Service Bulletin

SB 1394T100-10RA-01

Autopilot Turn Coordinator

Modification 1

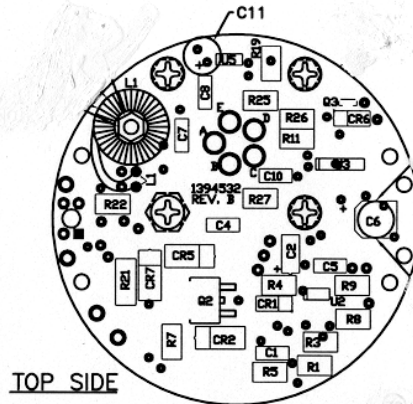
This service bulletin performs two changes to the Autopilot Turn Coordinator electronic circuit. The first change adds a 47 μ f Capacitor part number 7014582 in parallel with capacitor C9. This new capacitor is designated as C11.

The second change replaces resistor R21, 470 ohm, part number 53-4700J3TK-L with a 1,000 ohm, part number 53-1001J3TK-L.

- A. Remove cover from unit.
- B. From the circuit board side opposite the connector locate the two via holes as shown. Install the 47uf capacitor with the positive lead to the centermost hole.

- C. Locate resistor R21, if it is a 470 ohm, remove from circuit board using surface mount component removal techniques. Clean circuit paths. Install new 1,000 ohm resistor onto the circuit board.
- D. Install cover onto unit.
- E. Test unit i/a/w test specification TDS170.
- F. Identify service bulletin completion by placing a 3/8 inch orange label on the rear of the cover adjacent to the connector.
